COMMENTS AND RESPONSES TO COMMENTS

This chapter of the final environmental impact report (Final EIR) contains the comment letters received during the public review period for the Draft EIR, which concluded on February 3, 2020. In conformance with Section 15088(a) of the State CEQA Guidelines, written responses were prepared to address comments on significant environmental issues received from reviewers of the Draft EIR.

Figure 1 Transportation Strategies Organization

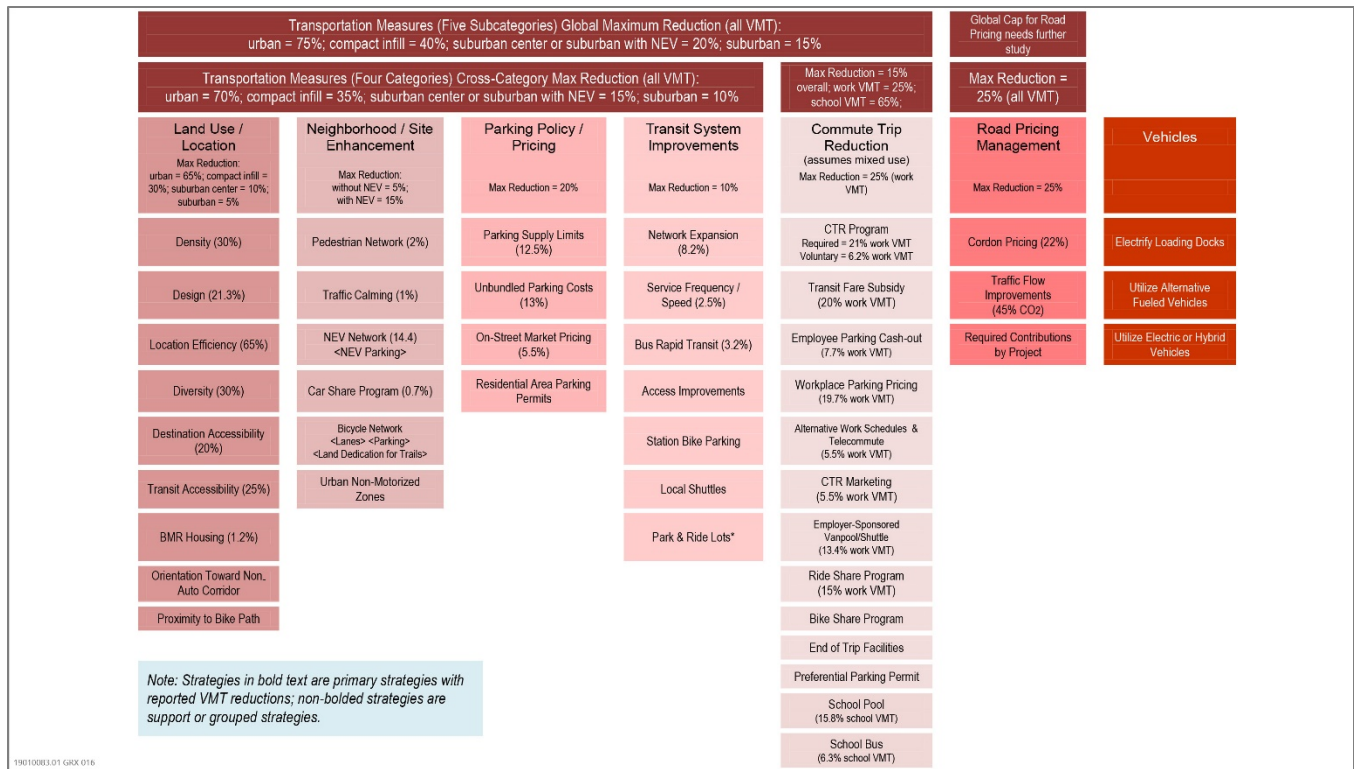
Several comments requested a more robust discussion of which TDM mitigation measures are realistic and a timeline for how and when they will be implemented. The menu of TDM mitigation measures identified in Draft EIR constitutes a robust set of proven measures capable of encouraging and achieving reductions in single occupant vehicle trips, increasing the use of alternative travel modes, and achieving lower per capita VMT (California Air Pollution Control Officers Association [CAPCOA] 2010). The initial set of TDM measures to be documented and implemented in the TDM Plan would include, but not be limited to, the strategies highlighted in the CSU TDM Manual, the Draft EIR, and those identified in Figure 1, below, from *Quantifying Greenhouse Gas Mitigation Measures* (Nelson Nygaard 2012, CAPCOA 2010). In addition to these strategies, the TDM Plan would also address new mobility options including bike sharing, e-bike sharing, and e-scooter sharing which are emerging transit modes that increase the viable travel choices in a community while reducing vehicle trips. These mitigation measures intentionally do not specify the exact location and/or the particular VMT reducing benefits because each of these measures' efficacy will evolve over time, and it is important to allow for the continued and/or expanded use of certain measures or use of different measures to effectively adapt to changing conditions within the campus, and changing conditions and approaches by other agencies in the area to achieve Cal Poly's commitment to the stated performance standard of 19.22 VMT per service population. Nonetheless, all the strategies and measures identified in the description of the mitigation measure are feasible and would be implemented as part of the TDM plan to achieve and maintain the performance standard of reducing per-service-population VMT by a further 5.04 VMT. The implementation of the outlined TDM strategies would also serve to minimize the need to expand the existing roadway system by improving the efficiency of existing transportation resources.

As shown below in Figure 1, VMT reductions can range from 15 percent to 75 percent, depending on the number and type of TDM measures implemented. As currently envisioned, the TDM Plan required by Mitigation Measure 3.13-1 would be developed and implemented immediately following approval of the 2035 Master Plan during the summer of 2020 with monitoring and annual surveys beginning in the fall of 2020. As further noted in the discussion of Mitigation Measure 3.13-1, the efficacy of the measures/actions would be evaluated every 2 years and adjustments to the various TDM actions and their level of implementation would be made to ensure that Cal Poly achieves the performance standard (i.e., 5.04 VMT per service population below pre-mitigation conditions of 19.22 VMT per service population or a 20.8 percent reduction in per-service-population VMT). As necessary, Cal Poly would add new or adjust the implementation level of certain measures. Based on the suite of transportation measures available to Cal Poly and the known levels of effectiveness of individual measures, it is reasonable to conclude that, through implementation, monitoring, and adaptive management in response to project- and site-specific conditions, Cal Poly can achieve the performance standard to which it is committed.
